Princeton 5881 T-O-N		
A C Held	Rev 6 2021-12-22

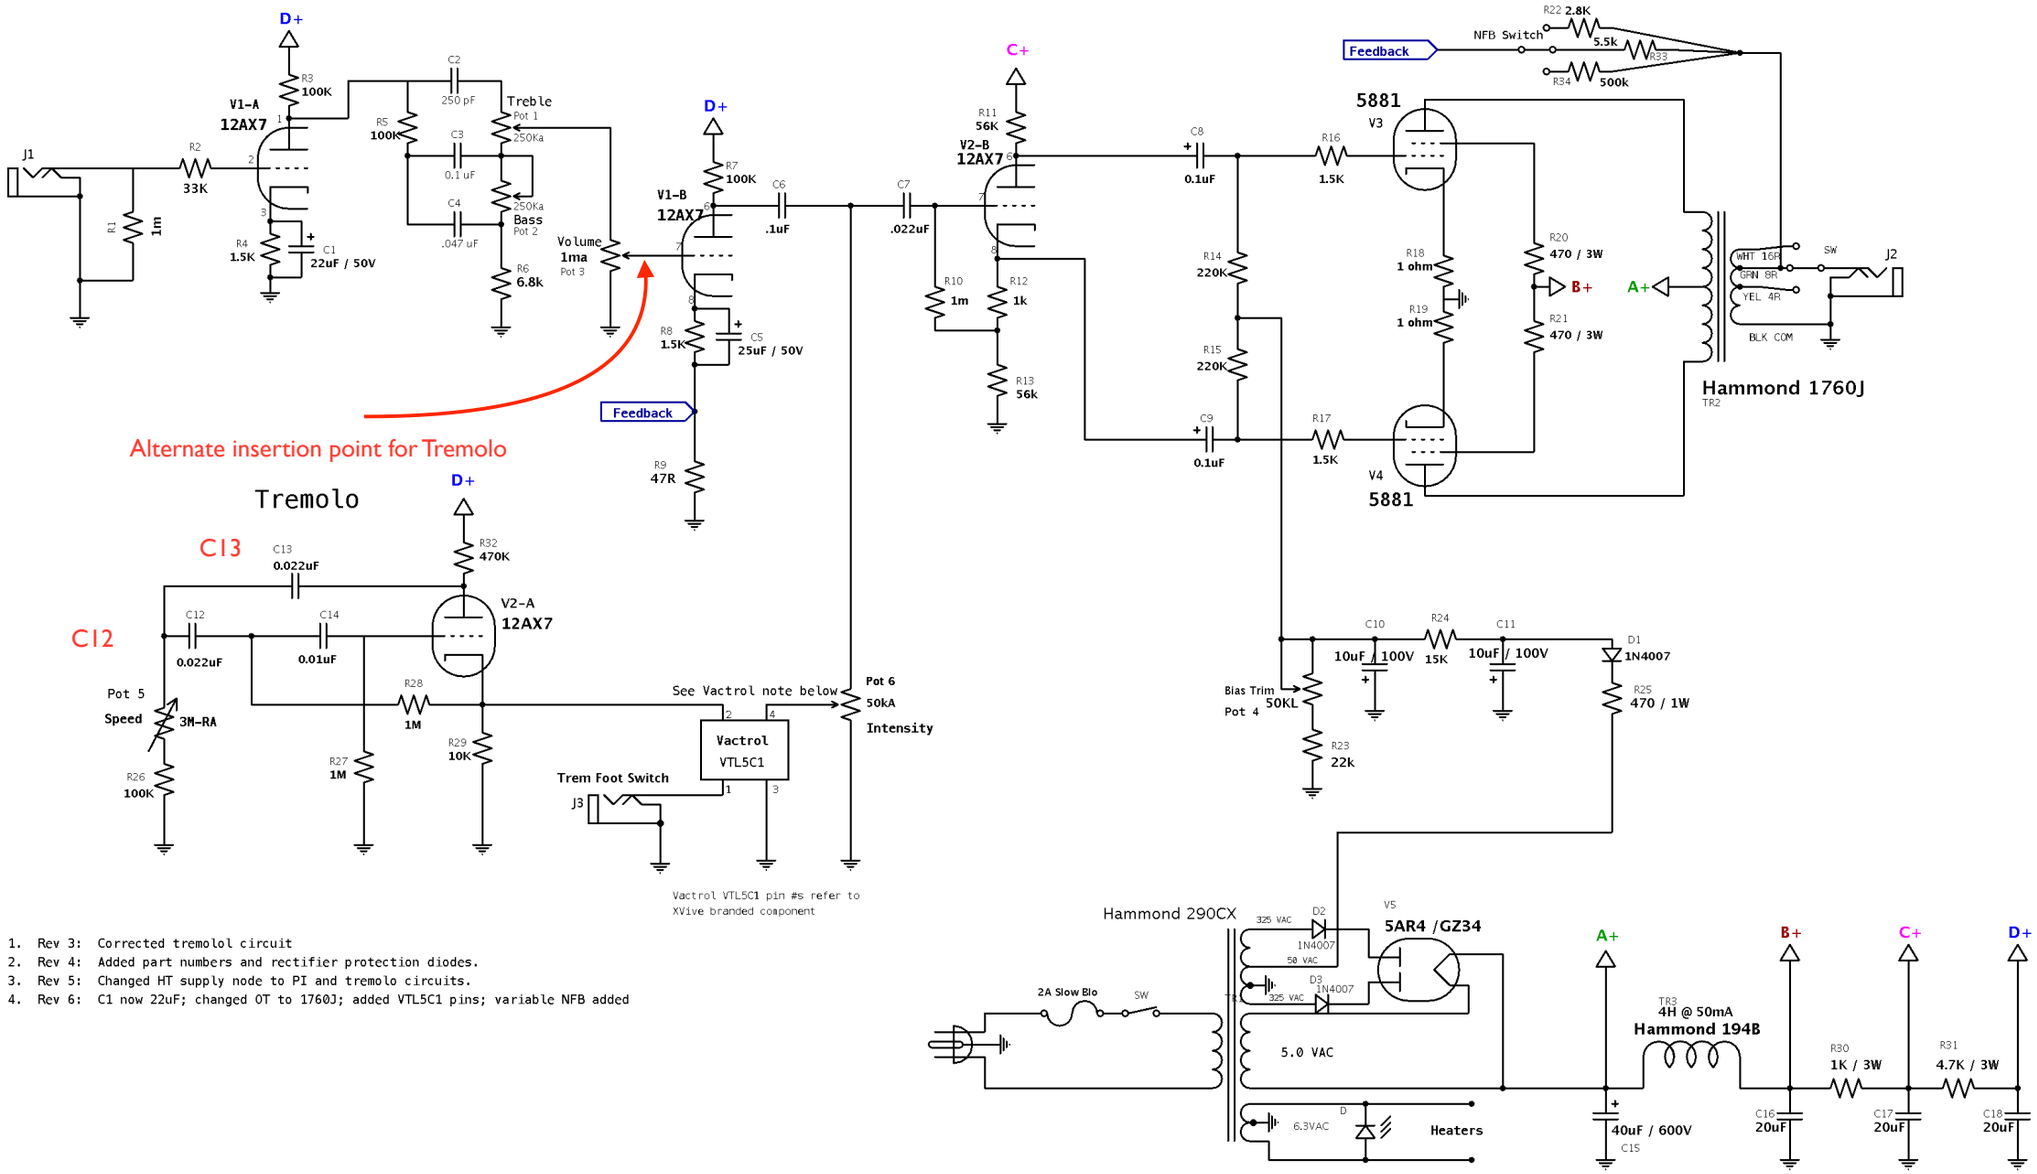
1. Rev 3: Corrected tremolol circuit
2. Rev 4: Added part numbers and rectifier protection diodes.
3. Rev 5: Changed HT supply node to PI and tremolo circuits.
4. Rev 6: C1 now 22uF; changed OT to 1760J; added VTL5C1 pins; variable NFB added
